RECALL

August 2019
FL804AB
NHTSA #18V-929 (School Buses)
#18V-930 (Non-School Buses)
Transport Canada #18-735 (School Buses)
#18-736 (Non-School Buses)

Subject: TBB Saf-T-Liner C2 Power Ports

Models Affected: Specific Model Year 2019-2020 Thomas Built Buses Saf-T-Liner C2 school buses and non-school buses manufactured January 1, 2018, through November 21, 2018, with an optional auxiliary outlet powered by the ignition and accessory power circuits.

Figure 2: In-Line Fuse Holder Location

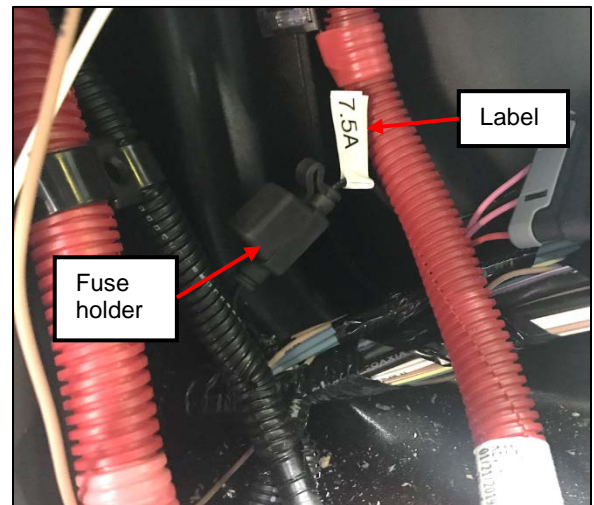
3. Replace the 10 AMP mini fuse for the aux port with a 7.5 AMP mini fuse. Discard the removed fuse. See **Figure 2** for location.
4. Type or hand write "7.5A" on an Avery 54254 label (or equivalent) and place it on the wire beside the fuse holder. See **Figure 3**.

Figure 7: Installation of New Harness

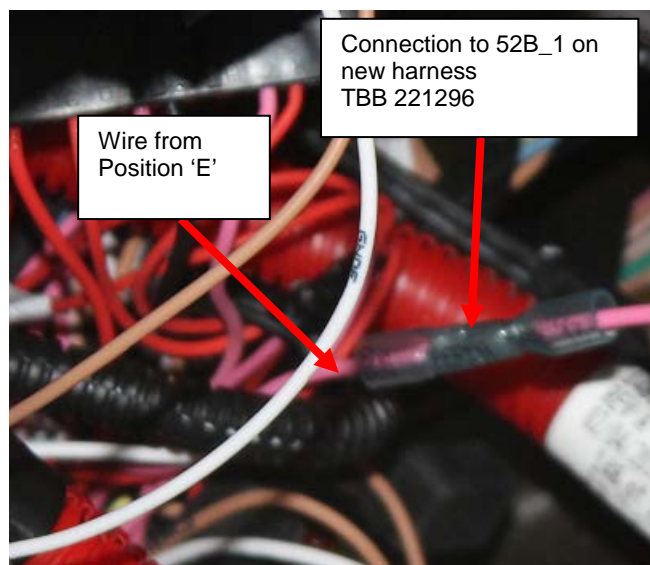
6. Using a pair of wire cutters, cut the wire at Position 'E' at a distance from the plug/connector just long enough to allow placing a cap or sealing butt splice on the wire. From TBB 221296, take the wire with the butt splice (52B_1) and connect it to the end of the wire just cut from the plug. See **Figure 7**.

Figure 8: Completed Wiring Connections

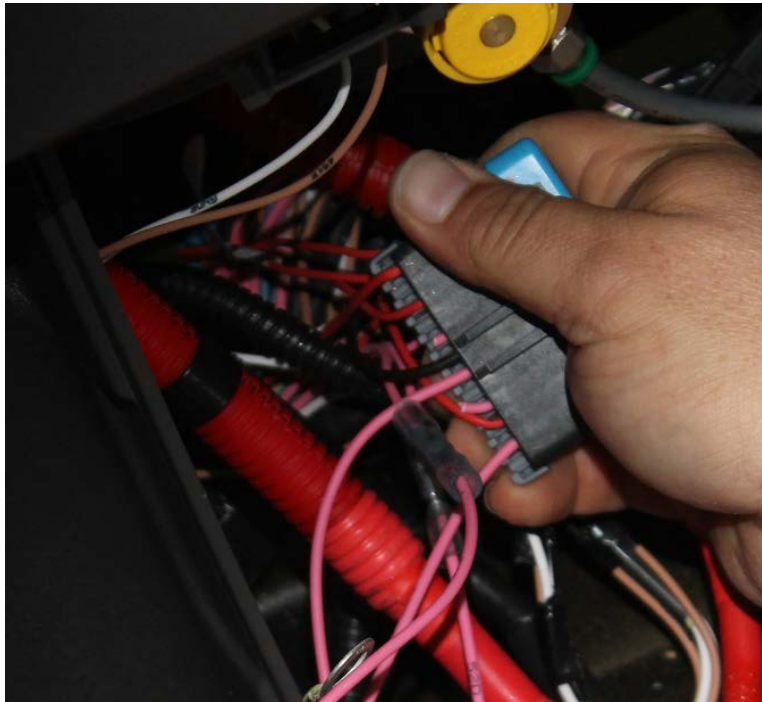
7. Push the terminal of wire 52B_1 (from new harness TBB 221296) into Position 'G' until it locks into place.
8. Cut the wire in Position 'J' and put a cap or sealing butt splice on it and install it. See **Figure 5** for location.
9. Take the remaining wire cut off from plug Position 'J' and connect it to 52D_1 from harness TBB 221296.
10. Push wire 52D_2 into the terminal at Position 'L' until it locks into place. See **Figure 7**.
11. Reinstall the gray wire "keeper" on the back side of the plug. See **Figure 8** for final installation.

Figure 9: Battery Wire Installation

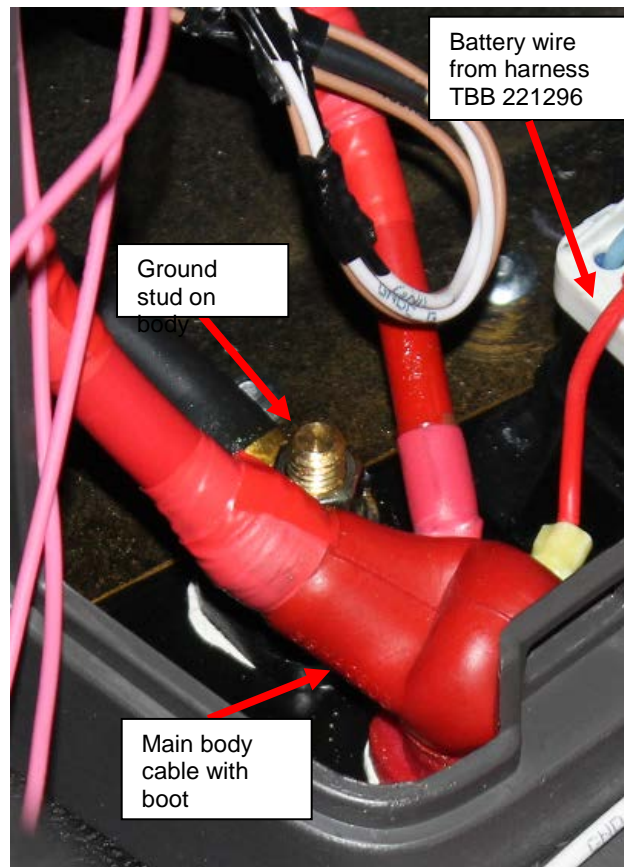
- 12.4 Attach the red wire with the ring terminal from harness TBB 221296 to the battery cable connection. Reinstall cables previously removed.
- 12.5 Tighten the nuts on the battery ground cables 140-150 lbf-ft.
- 12.6 Pull the boot back over the battery cable. See **Figure 9** for final power cable installation.

Figure 10: Battery and Ground Cable Installation

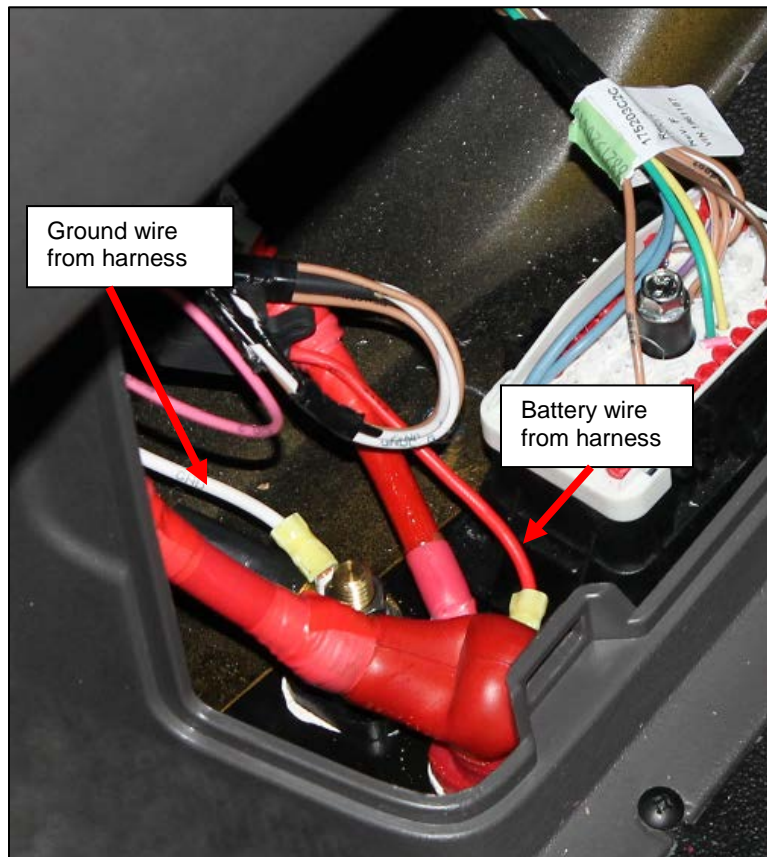
13. Install the ground from TBB 221296 by removing the nut and washer (if a washer is present). See **Figure 10** for location of the ground.
14. Attach the ring terminal to the ground stud and reinstall any terminals that were removed earlier. Reinstall the nut and washer. See **Figure 10** for final installation of the battery and ground wires.
